**BELLEFONTE COMBINED LICENSE APPLICATION – RESPONSE TO ENVIRONMENTAL REPORT REQUEST FOR ADDITIONAL INFORMATION - HYDROLOGY**

Reference: Letter from Mallecia Hood (NRC) to Ashok S. Bhatnaker (TVA), Request for Additional Information Regarding the Environmental Review of the Combined License Application for Bellefonte Nuclear Plant, Units 3 and 4, dated July 11, 2008 [ML081840493].

ENCLOSURE 1  
RESPONSE TO ENVIRONMENTAL REPORT REQUESTS FOR ADDITIONAL INFORMATION  
HYDROLOGY

**FIGURE 2.3-23 (Sheet 1 of 4)**  
**March 2005 Potentiometric Surface Map**

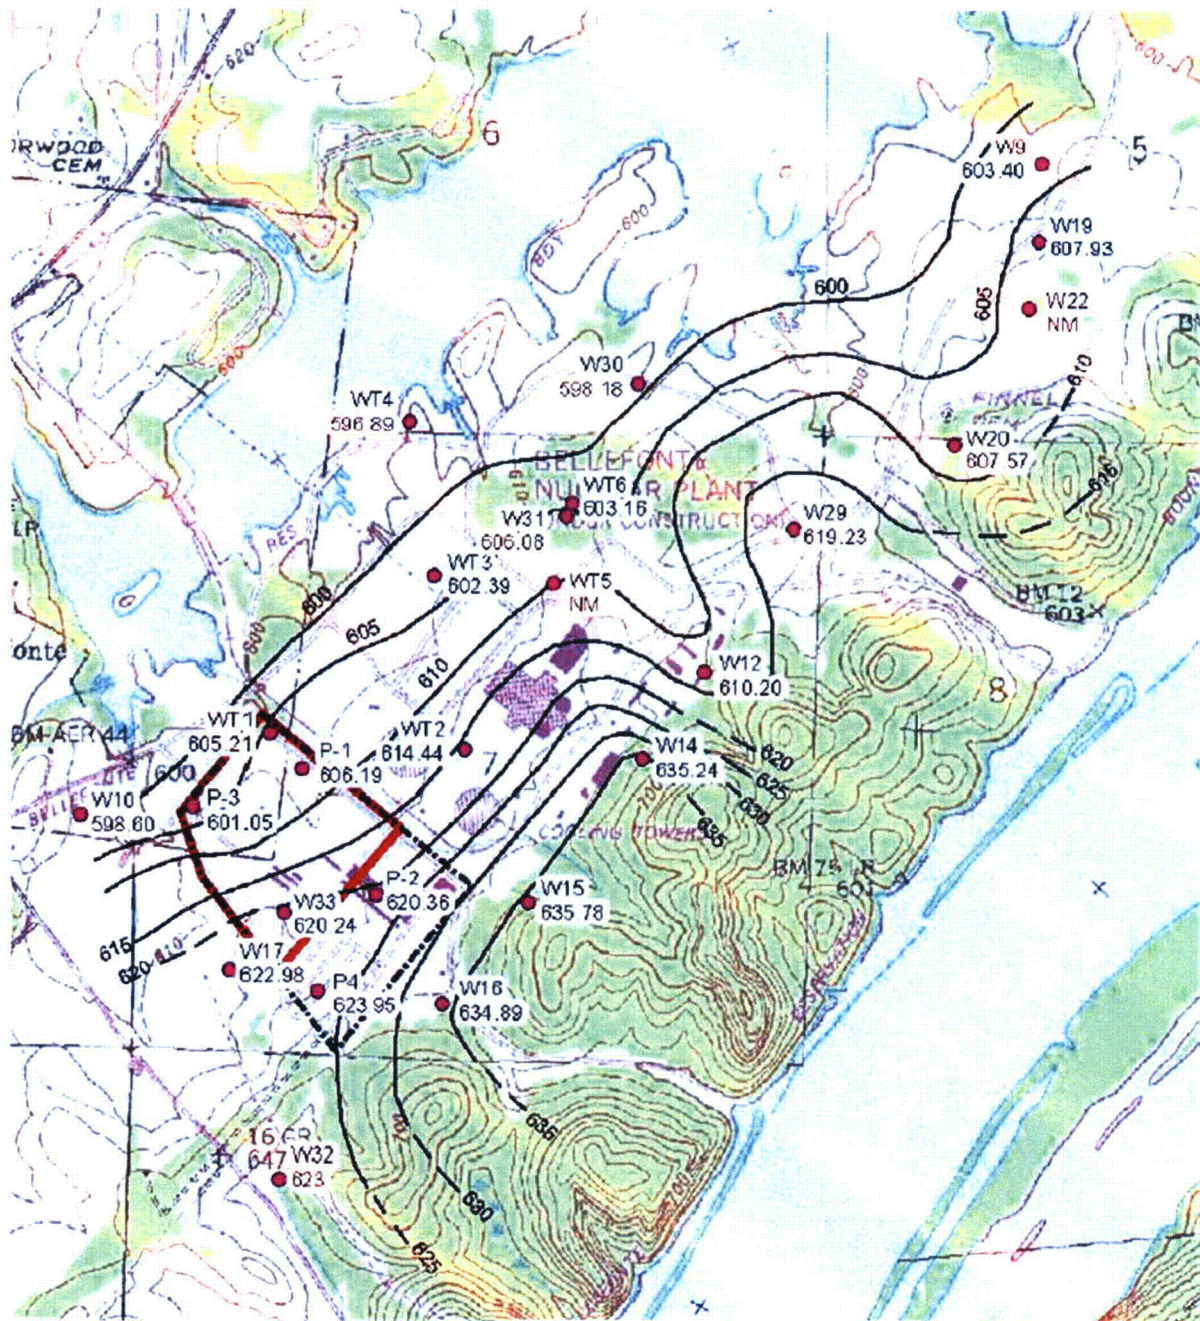
Edit the caption for ER Figure 2.3-23 to address concerns over W29 data.

In response to this RAI 2.3-1, annotation is added to Figure 2.3-22 (Sheet 1 of 4) to provide clarity regarding the anomalous reading for W29 in March 2005. It is also apparent that the interpretation of the groundwater equipotential lines around W29 in ER Figure 2.3-23 (Sheet 2 of 4) was influenced by the March 2005 reading; therefore, similar annotation is added to ER Figure 2.3-23 (Sheet 2 of 4).

1. Change COLA Part 3, ER Chapter 2, Figure 2.3-23 (Sheet 1 of 4) by adding the following note to the legend/caption area:

Note: The March 2005 reading from Well W29 is considered an anomalous reading, and the water level and interpretation of the groundwater elevations in the vicinity of Well W29 depicted in this figure are not considered in current groundwater evaluations.

**Note:** The March 2005 reading from Well W29 is considered an anomalous reading, and the water level and interpretation of the groundwater elevations in the vicinity of Well W29 depicted in this figure are not considered in current groundwater evaluations.

ATTACHMENT 5.2-1  
DREDGED MATERIAL AREA  
JULY 2008

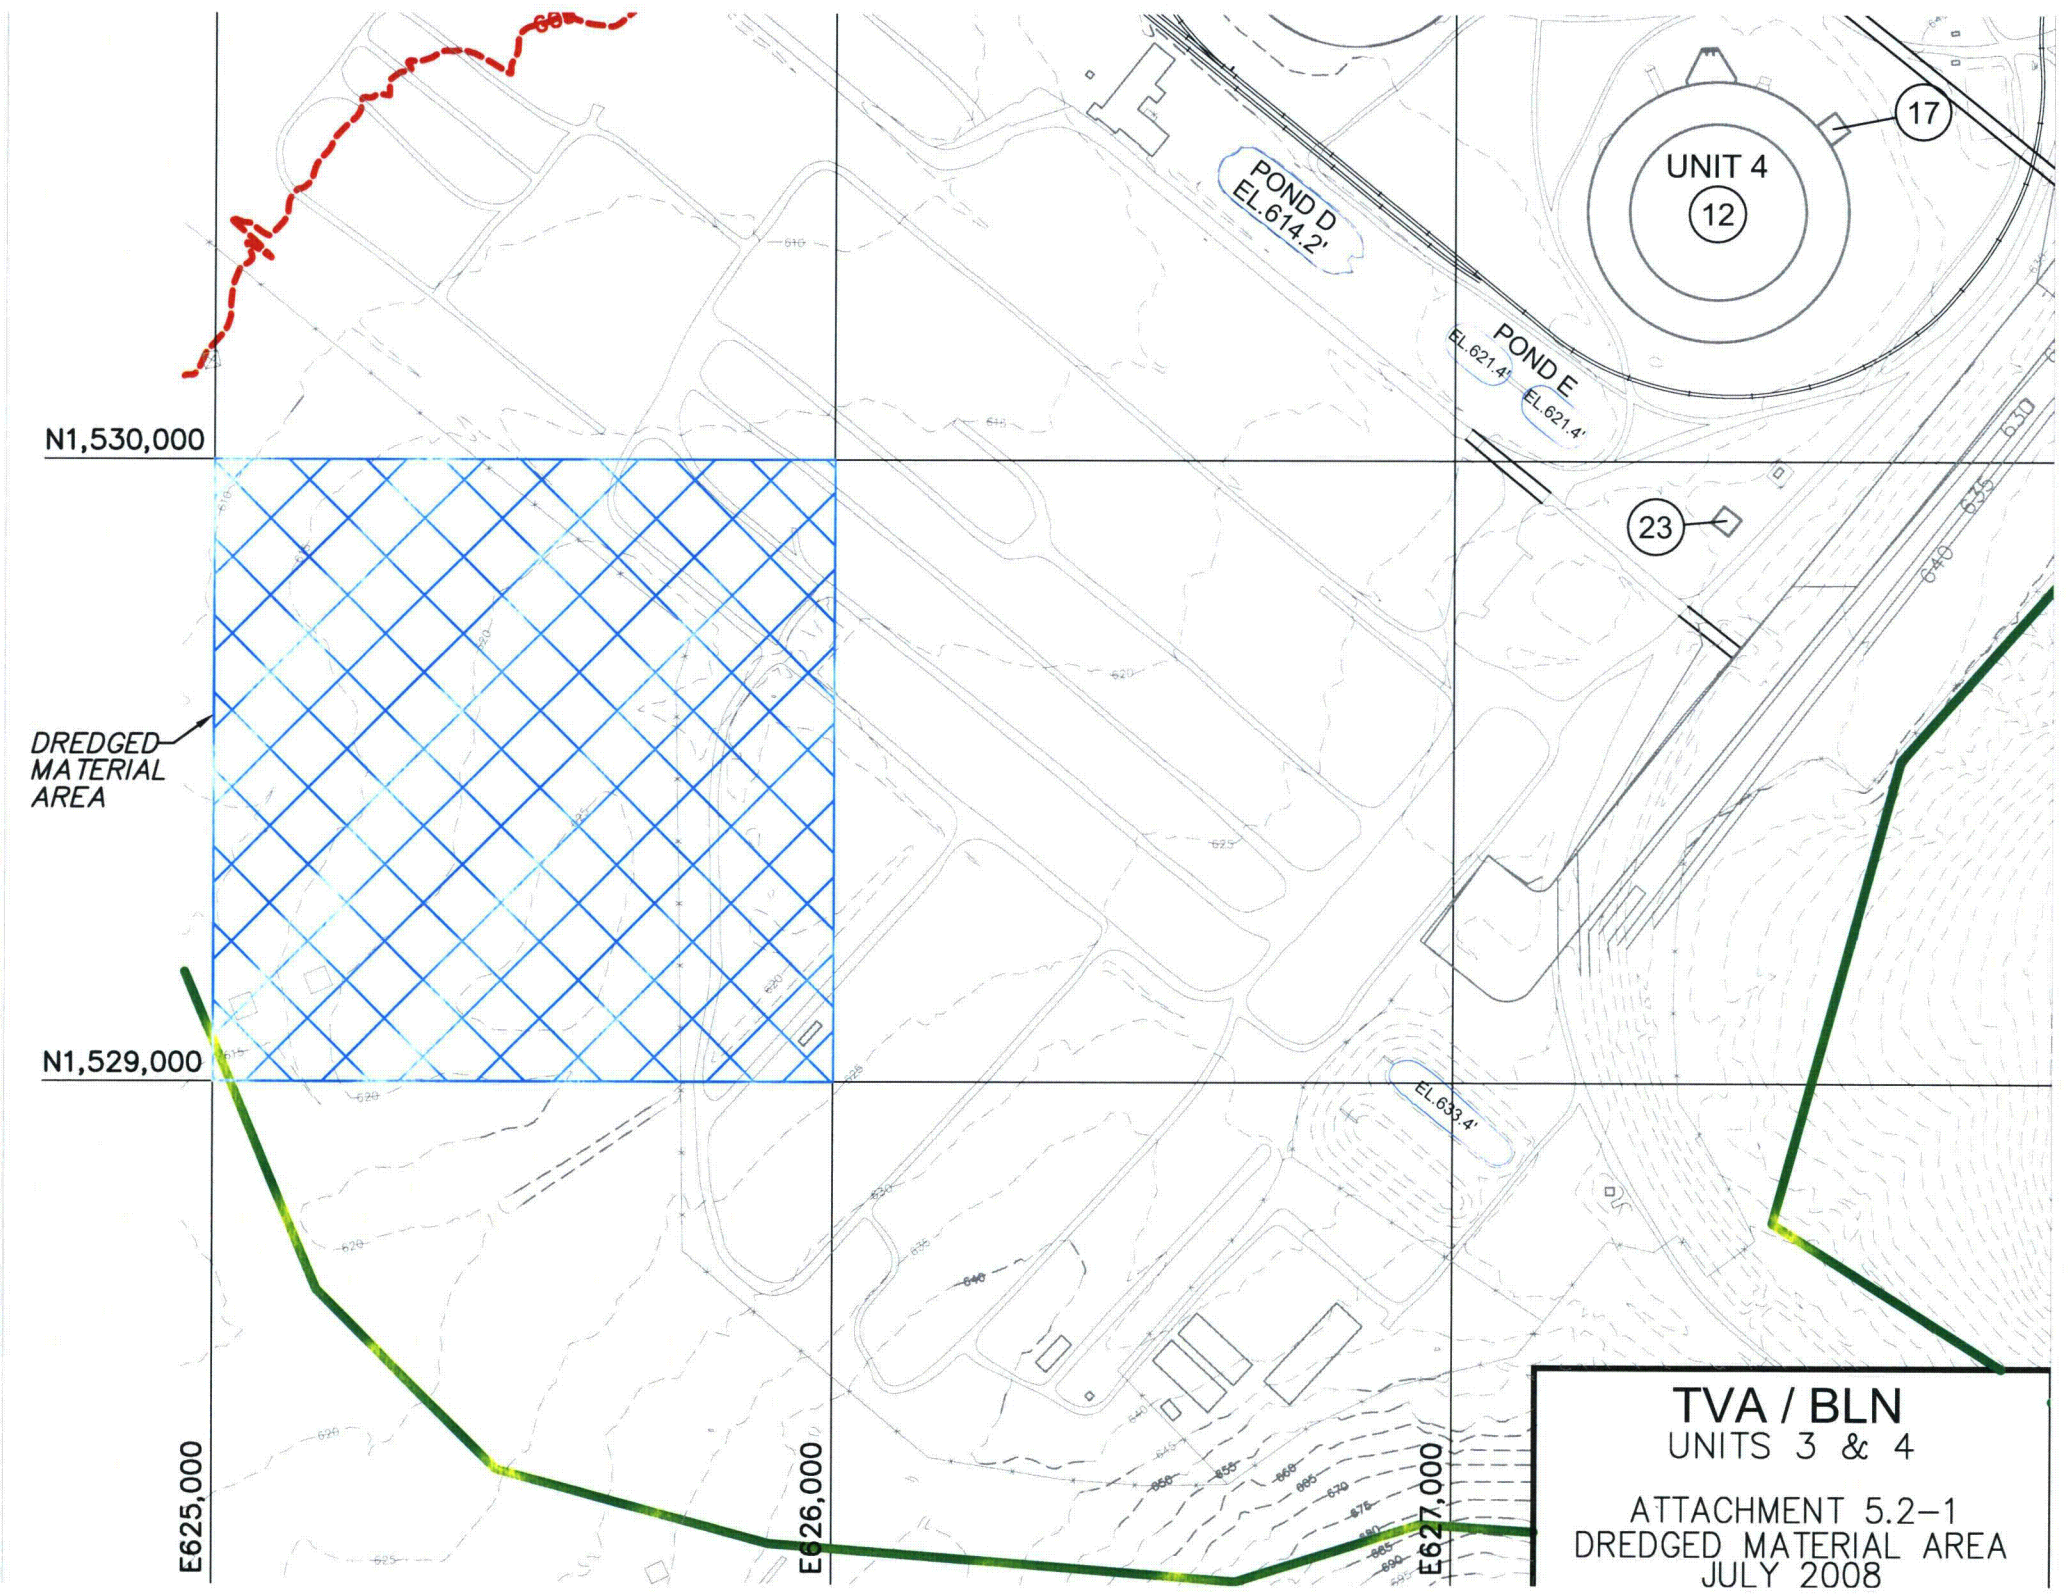
Using a figure, identify the on-site area or areas that may be used for dredged material deposition.

The area within the 500-year floodplain and the area of potential effect (APE) that is expected to be used for dredged material deposition (spoils) is illustrated in Attachment 5.2-1 as the cross-hatched area that lies between E625,000 and E626,000 and between N1,529,000 and N1,530,000. This figure is a marked-up excerpt from TVA/BLN Drawing DWG-NUSTART-004, which was provided as Attachment C in the referenced TVA letter dated June 12, 2008.

**Service Manual**  
**Envirex Traveling Water Screen**  
**- Four Post -**  
**(Data Sheet No. 330.3.022.02.01, Page 4 of 5)**  
**and**  
**Installation Drawing Illustrating Base**  
**Elevation of the Screen**  
**(Two installation drawings)**

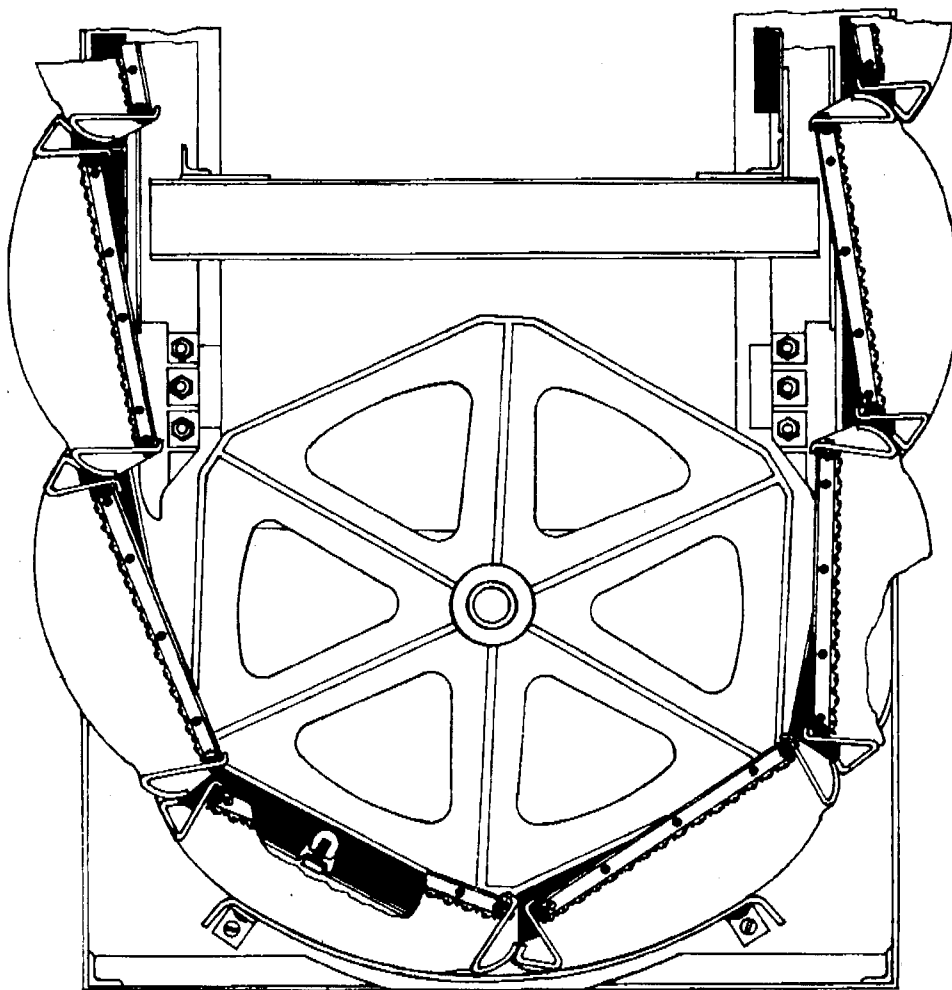
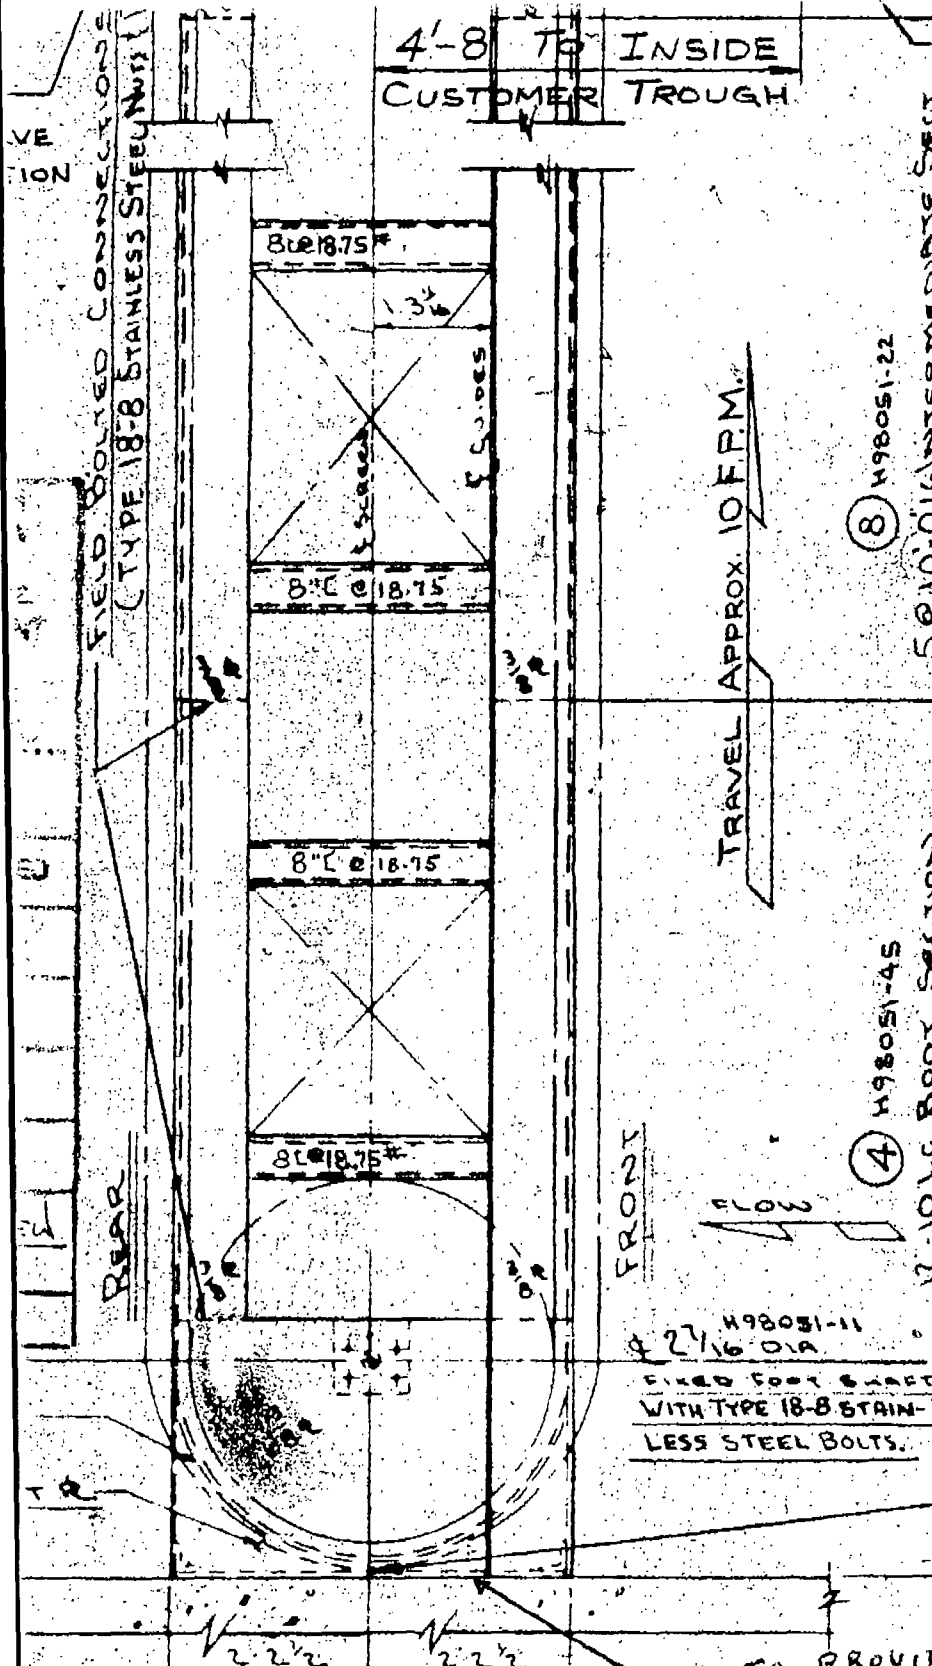
Explain how the description of the water velocity through the screens is consistent in the three sections (Sections 3.4.2.1, 5.3.1.1.1, and 5.3.1.1.1) in which it is presented. Provide the background information sufficient to check this calculated velocity (e.g., water withdrawal rate, base elevation of screen, minimum pool elevation {top of screen}, width of screen, number of screens, area of screen).

Subsection 3.4.2.1 is corrected to indicate the through-screen velocity at minimum normal pool elevation is 0.13 fps, which is well under the 0.50 fps requirement of Section 316(b) of the Clean Water Act, and is consistent with the associated language in Subsection 5.3.1.2.1 that states flow velocity through the screens during operational mode is well under 0.50 fps. Subsection 5.3.1.1.1 correctly states that flow velocity is less than 0.50 fps; however, this subsection is revised to indicate the use of the minimum normal pool elevation to calculate the maximum velocity, as noted below.

The calculation for maximum velocities provided for review at the BLN site audit was revised in May 2008 to better define the flow velocity for maximum velocities through clean screens. The calculation provides information on water withdrawal rate, base elevation of the screens, minimum pool elevation, width of screen, number of screens, and area of screen. Attachment 5.3-1 illustrates the base elevation of the traveling screen. The revised calculation is made available for NRC reviewers at NuStart's contractor's offices.
